SERVICE BULLETIN

APPLICABILITY: 2012-13MY Impreza 2.0L 4-Door Sedan Models

NUMBER: 07-78-13R

SUBJECT: Insect Entry into Rear Combination Lamps

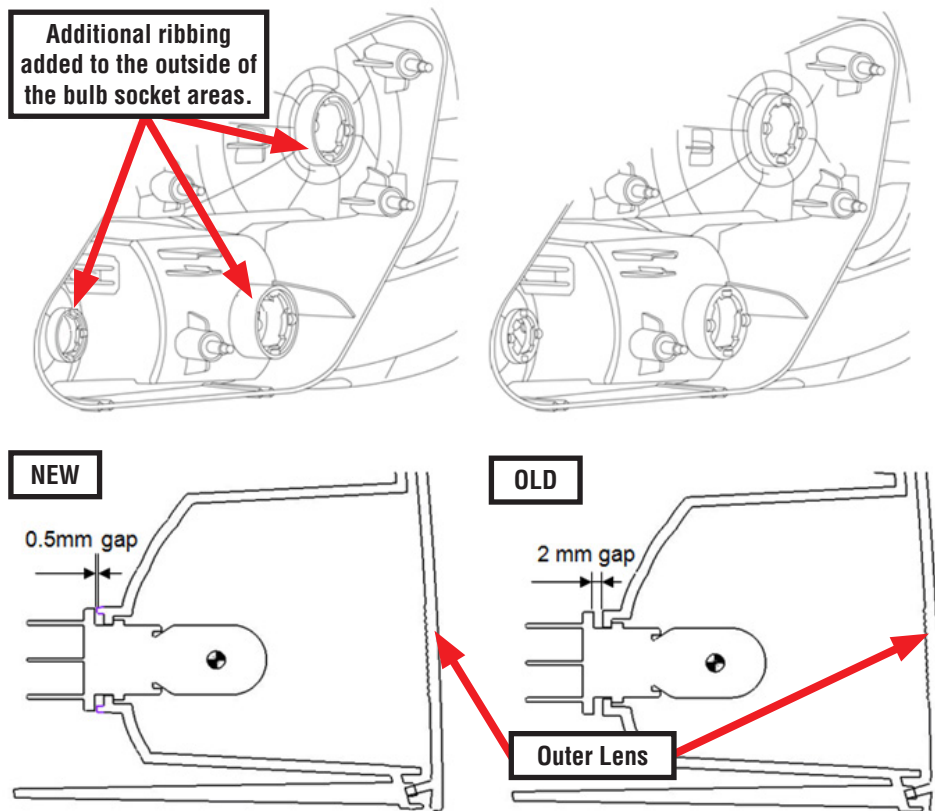
In the event of a customer concern regarding insects found inside the rear combination lamps, a countermeasure lamp assembly is now available to prevent the intrusion. The new combination lamps have an additional lip molded around the three bulb socket areas which decreases the gap between the socket and the housing from 2mm to 0.5mm.

The countermeasure combination lamps were incorporated into production 6/20/2013. Reference illustrations below show the difference between the old and new style combination lamps.

SERVICE PROCEDURE / INFORMATION

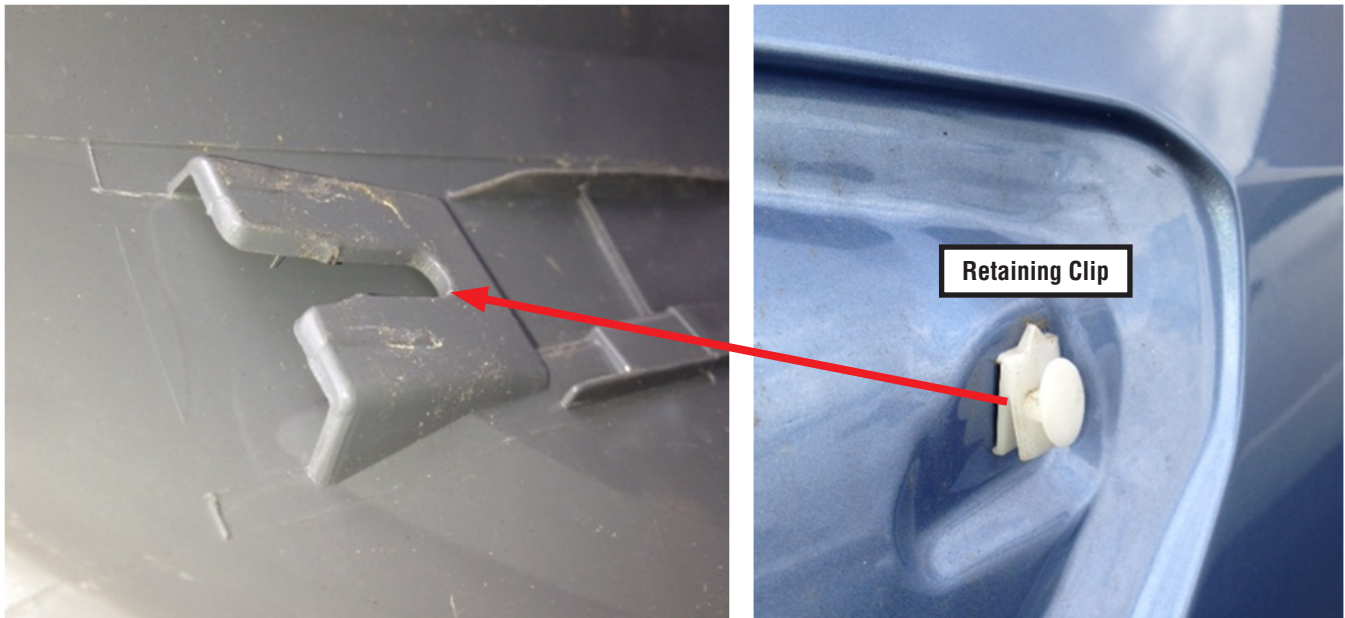
- Disconnect the combination lamp wiring harness connector and remove the four retaining nuts. Then slide the lamp assembly directly rearward to disengage it from the retaining clip. Be careful not to damage the retaining clip.

- Always replace the packing / gasket (included) with the new combination lamp assembly.
- After confirming the new lamp assembly is properly slid back on to the retaining clip, tighten the 4 retaining nuts to 7.5 Nm (5.5 ft. lbs.).
